Groundwater Application Review Summary Form

Application # G- 18766

To: Kristopher Byrd, Well Construction and Compliance Section Manager
From: Joel Jeffery, Well Construction Program Coordinator
Subject: Review of Water Right Application G-18766
Date: May 16, 2019

PUBLIC INTEREST REVIEW FOR GROUNDWATER APPLICATIONS

- (7) Diagram showing the pertinent features of the proposed well design and construction:
(attach additional pages if needed)

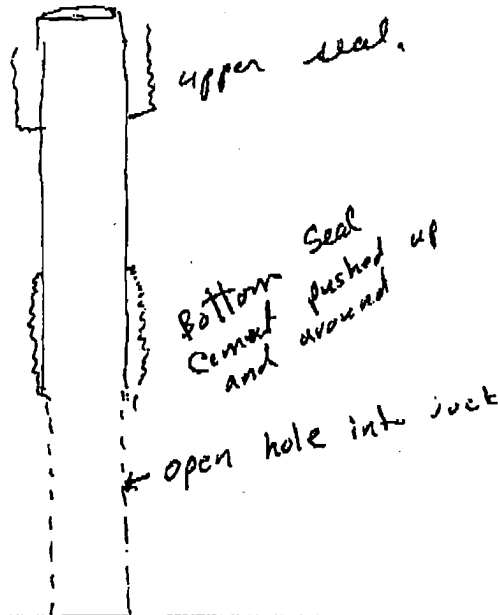
(5) The unusual site conditions which necessitate this request: underreaming into

basalt rock with 9.5 in reamer.

Seal approx 20 ft into basalt rock

Remarks: Small lower borehole for underreaming

The Special Standard request you submitted for owner: JLPN Inc., Start Card number 183628 is hereby approved for the following: You may install this well using an under-reaming system. The lower under-reamed borehole shall be at least 9.5 inches and you may install eight inch steel casing. The lower seal shall be placed at least 20 feet into solid, uncreviced, consolidated rock overlying the water bearing zone. See Oregon Administrative Rule (OAR) 690-210-0150. The upper seal shall be placed according to standards. Your Special Standard request form is enclosed. This Special Standard was verbally approved on December 6, 2005.

D. WELL CONSTRUCTION, OAR 690-200

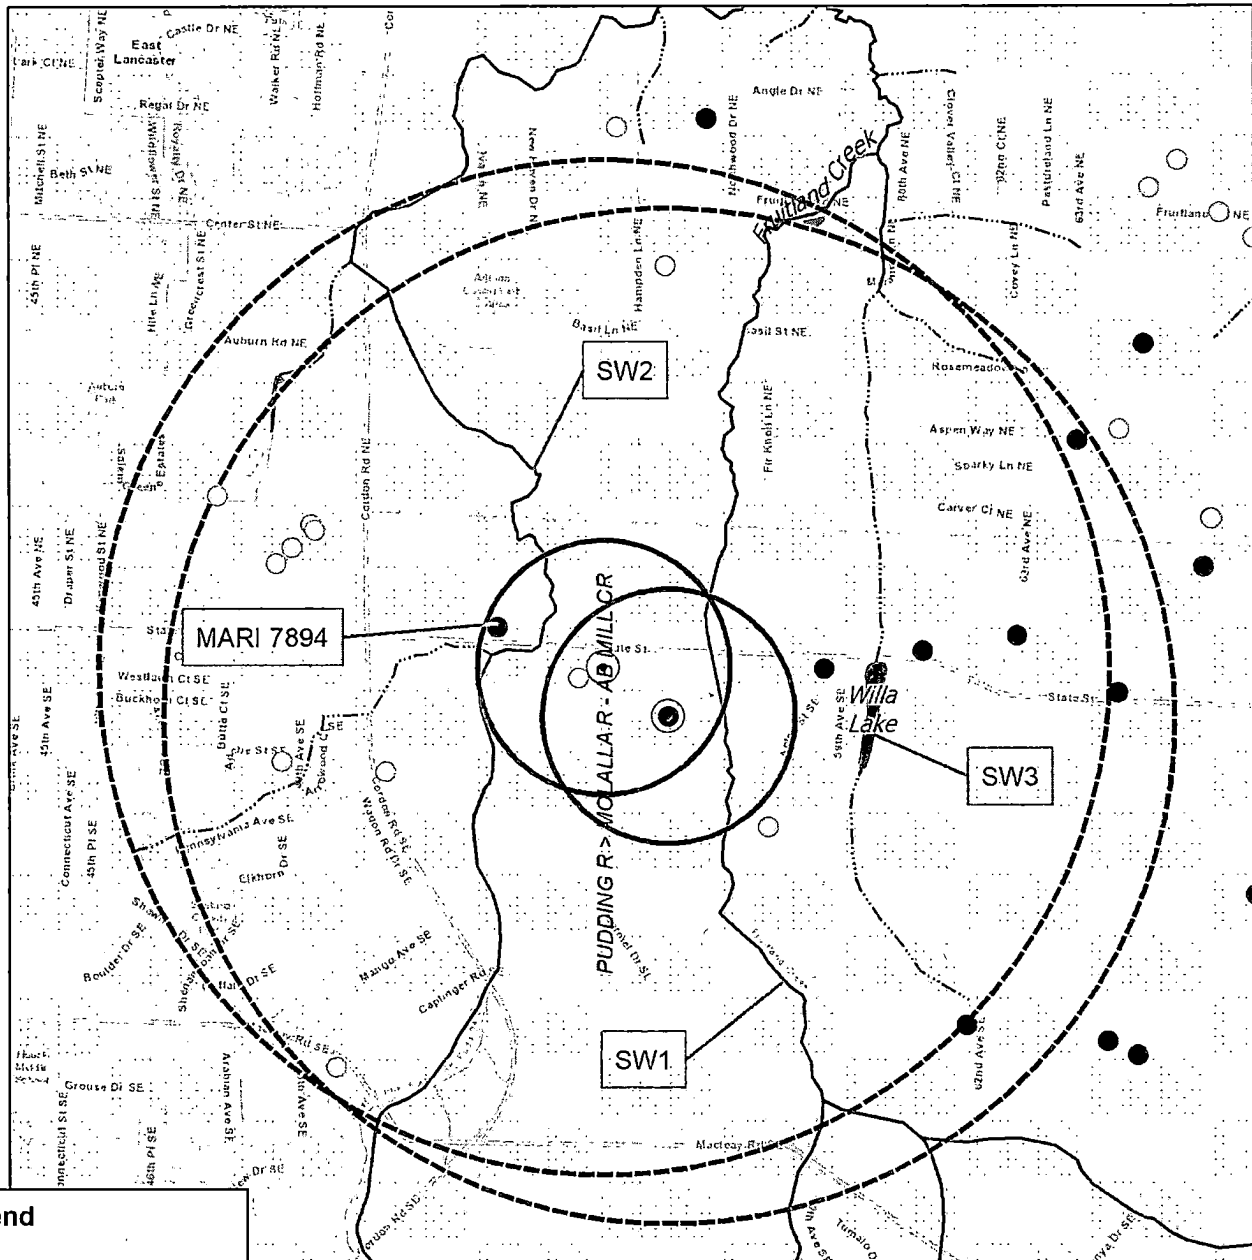
D2. **THE WELL does not appear to meet current well construction standards based upon:**

- a. review of the well log;
- b. field inspection by _____;
- c. report of CWRE _____;
- d. other: (specify) _____

D3. **THE WELL construction deficiency or other comment is described as follows:** _____

D4. **Route to the Well Construction and Compliance Section for a review of existing well construction.**
